**NRC Staff
Request for Additional Information
on
Electric Power Research Institute Report 3002005564,
“Development of Generic Scaling Factors for Technetium-99 and Iodine-129 in Low and
Intermediate Level Waste”**

The NRC staff has reviewed EPRI Report No. 3002005564 and developed this request for additional information (RAI) to obtain sufficient information to decide whether to approve for use the findings documented in EPRI Report No. 3002005564. To conduct its detailed review, the NRC staff considered the following regulations (and related NRC guidance) from Title 10 of the *Code of Federal Regulations* (10 CFR) in its evaluation:

Figure 1. Ratio of I-129 to Cs-137 in Samples Analyzed in NUREG/CR-6567

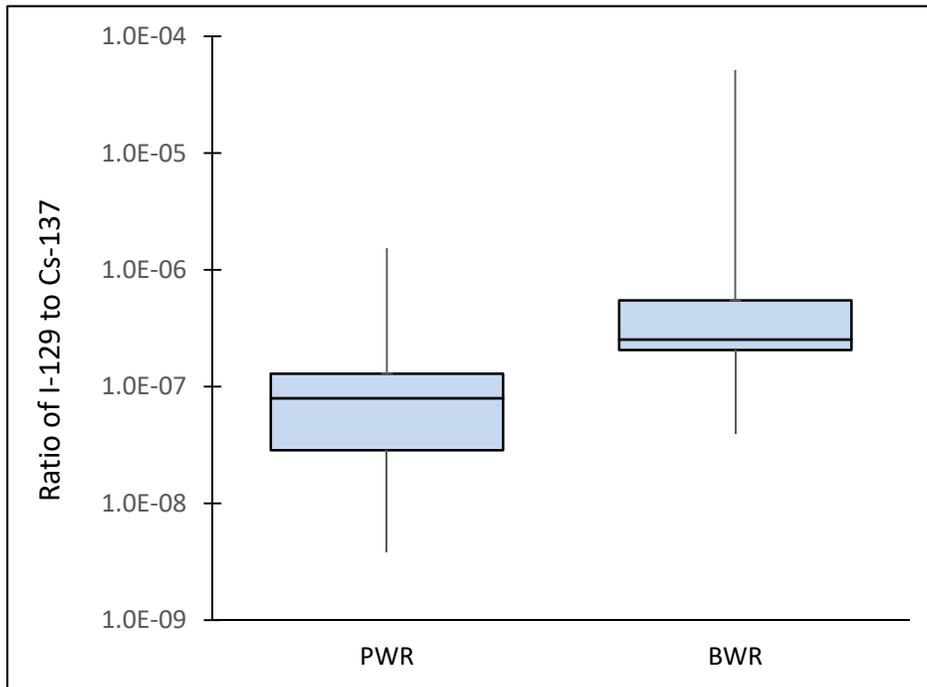
The proposed scaling factor for quantifying the activity of I-129 based on a measured activity of Cs-137 potentially underestimates the activity in waste from Boiling Water Reactors (BWRs).

However, an independent evaluation of the NUREG/CR-6567 data by the NRC staff found that calculated ratios of I-129 to Cs-137 were generally higher for the BWR samples than samples from Pressurized Water Reactors (PWRs) (**Error! Reference source not found.**). The geometric mean of the I-129-to-Cs-137 ratio from all BWR samples was 4.2×10^{-7} while the geometric mean from all PWR samples was 6.5×10^{-8} . Based on the data in NUREG/CR-6567, it appears that the use of the proposed scaling factor could result in the underestimation of the activity of I-129 in LLW from BWRs.

- (a) Provide justification that the proposed scaling factor for I-129 based on the measured Cs-137 activity is appropriate for all LLW from BWRs. Alternatively, provide a description of and basis for the specific conditions under which it would be appropriate to use the proposed scaling for LLW from BWRs.
- (b) Provide information on the representativeness of the two samples for which the use of the proposed I-129/Cs-137 scaling factor would result in more than a factor of 10 underestimation in the activity of I-129. If the samples are determined to be not representative of BWR LLW, provide a description of what properties of the waste and/or plant conditions caused the samples to not be representative.

Figure 2. Ratio of measured I-129 to predicted I-129 based on the proposed scaling factor

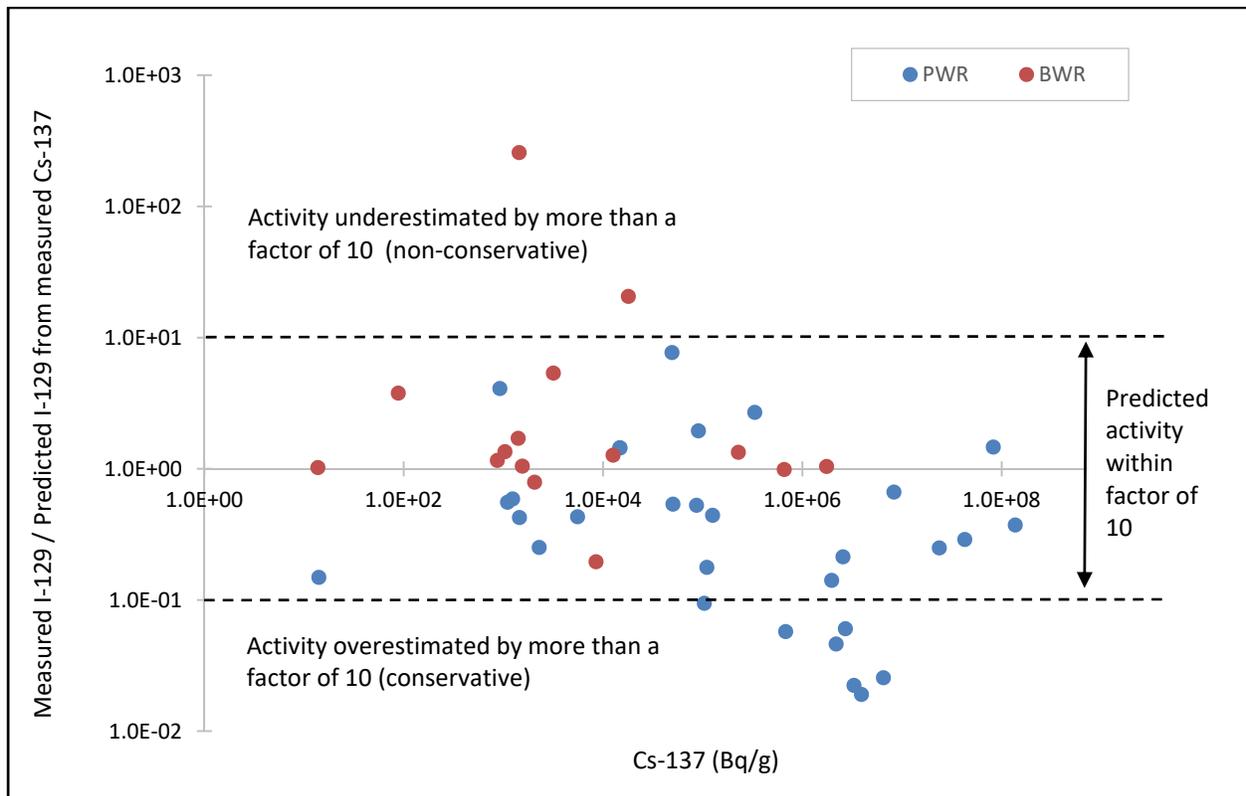
Additionally, this scaling factor would have resulted in the underestimation of the I-129 by more than an order of magnitude in two of the NUREG/CR-6567 BWR samples (Figure 2). It is not clear if these samples are representative of typical BWR LLW or if there is a known explanation for why the relative ratio of I-129 to Cs-137 might differ for these samples. If the samples are believed to be representative of typical BWR LLW, then the data from these results indicate that there is not reasonable assurance that the proposed scaling factor would result in a predicted activity of I-129 that is within a factor of 10 of the actual activity. However, if the samples are not representative of BWR LLW, then the proposed scaling factor could be restricted to waste streams that do not have the same properties as those samples.

Figure 3. Ratio of measured I-129 to predicted I-129 based on the proposed I-129/Co-60 scaling factor

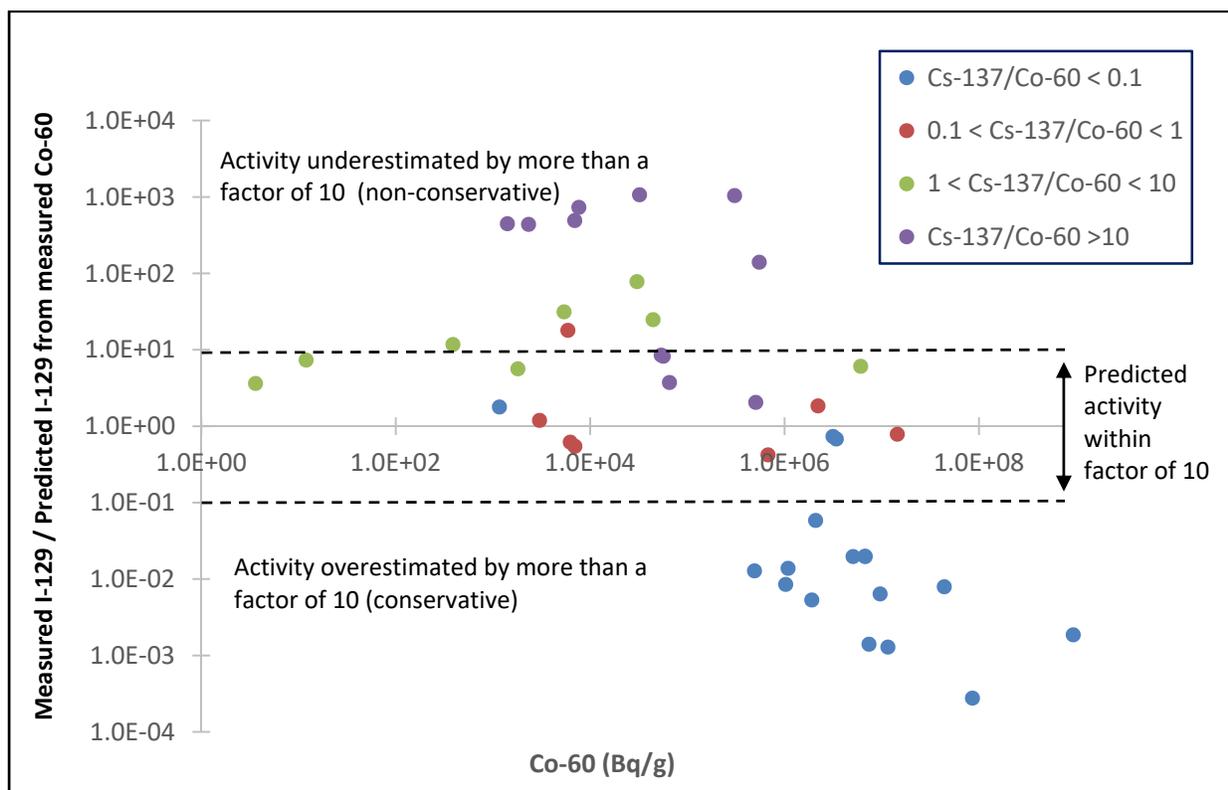
An independent analysis by NRC staff found that the use of the I-129/Co-60 scaling factor consistently resulted in an acceptable prediction of the I-129 activity for the waste streams in the NUREG/CR-6567 (NRC, 2000) dataset when the ratio of Cs-137 to Co-60 was less than 0.1 (Figure 3), which would be expected to be true when Cs-137 is not present in detectable quantities. However, Cs-137 was detected in all these samples and there are no sample measurements that can be used to confirm that the scaling factor is appropriate when the activity of Cs-137 is below the detection limit.

- (a) Justify that the I-129/Co-60 scaling factor is appropriate when Cs-137 is not present above the detection limit by providing the following information:
 - (i) A description of the range of conditions under which the use of the I-129/Co-60 scaling factor is appropriate and the situations that could lead to a change in the correlation or cause the indirect method to no longer be appropriate; and
 - (ii) Additional information to demonstrate that the data used to generate the I-129/Co-60 scaling factor is applicable when Cs-137 is not present above the detection limit given that Cs-137 was detected in all the samples considered in EPRI Report No. 3002005564.

- (b) Alternatively, demonstrate that there is reasonable assurance that a reasonably bounding activity of I-129 that could be present when Cs-137 is not detected would not cause a significant long-term risk at a disposal facility.

Figure 4. Ratio of measured Tc-99 to predicted Tc-99 based on the proposed Tc-99/Co-60 scaling factor

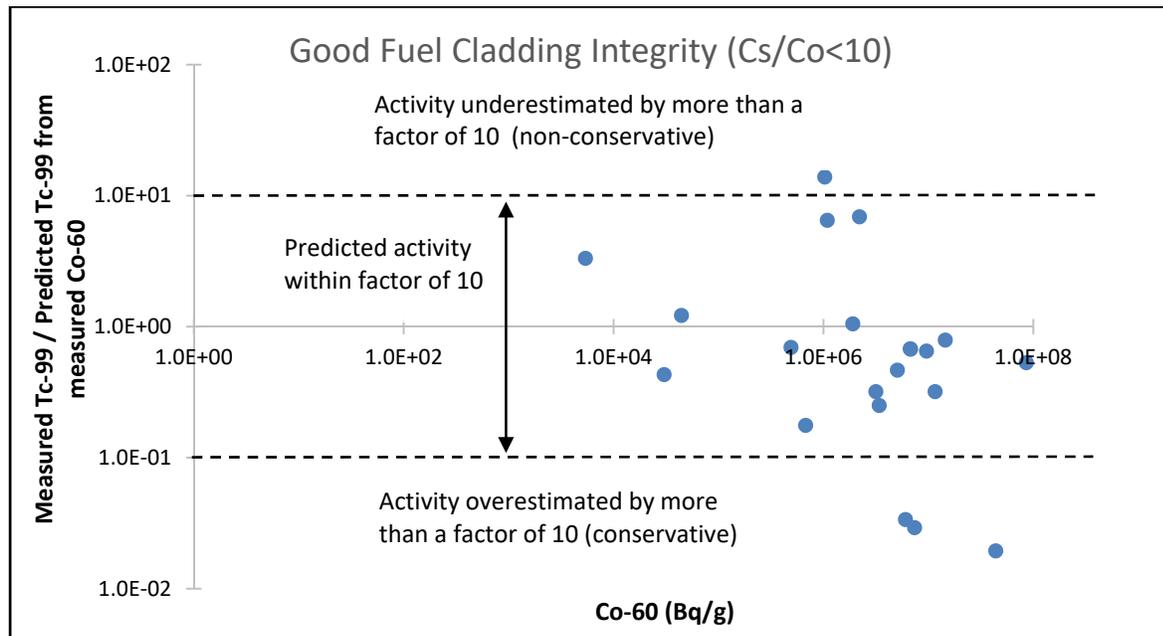
An independent analysis by the NRC staff found that the use of the Tc-99/Co-60 scaling factor consistently resulted in an acceptable prediction of the Tc-99 activity for the samples in the NUREG/CR-6567 (NRC, 2000) dataset except for one sample (Figure 4). Based on this, it appears that there are some conditions under which the proposed Tc-99/Co-60 scaling factor would not adequately estimate the activity of Tc-99. A description of the conditions under which this scaling factor would not be applicable is needed.

- (a) For the NRC staff to conclude that it is appropriate to predict the Tc-99 activity based on the Co-60 activity, the following information is needed:
 - i. Additional data to support the conclusion that the relative ratio of Co-59 to Mo-98 is relatively consistent from plant to plant and over the operating history of the power plants; and
 - ii. A description of the range of conditions under which the use of the Tc-99/Co-60 scaling factor is appropriate and the situations that could lead to a significant change in the correlation that would cause the proposed scaling factor to no longer be appropriate.

Figure 5. Ratio of measured Tc-99 to predicted Tc-99 based on the proposed Tc-99/Cs-137 scaling factor

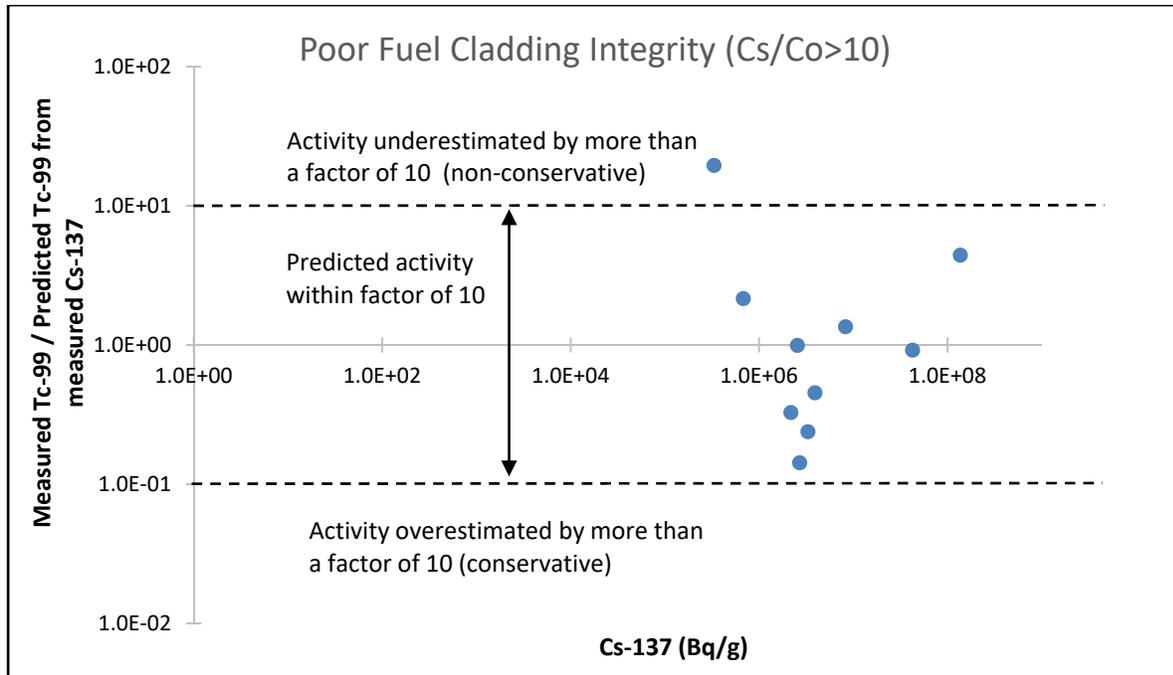
An independent analysis by the NRC staff found that the use of the Tc-99/Cs-137 scaling factor consistently resulted in an acceptable prediction of the Tc-99 activity for the samples in the NUREG/CR-6567 dataset except for one sample (Figure 5). Based on this, it appears that there are some conditions under which the proposed Tc-99/Cs-137 scaling factor would not adequately estimate the activity of Tc-99. A description of the conditions under which this scaling factor would not be applicable is needed.

- (b) For the NRC staff to conclude that it is appropriate to predict the Tc-99 activity based on the Cs-137 activity, the following information is needed:
- i. A basis for concluding that a sufficient number of samples was collected to have reasonable assurance that the proposed Tc-99/Cs-137 scaling factor is appropriate or provide additional measurement results demonstrating that this scaling factor is appropriate;
 - ii. If the proposed Tc-99/Cs-137 scaling factor is intended for use for LLW other than other than PWR resin, a justification that the PWR resin data are applicable to other waste streams; and
 - iii. A description of the range of conditions under which the use of the Tc-99/Cs-137 scaling factor is appropriate and the situations that could lead to a significant change in the correlation that would cause the proposed scaling factor to no longer be appropriate.
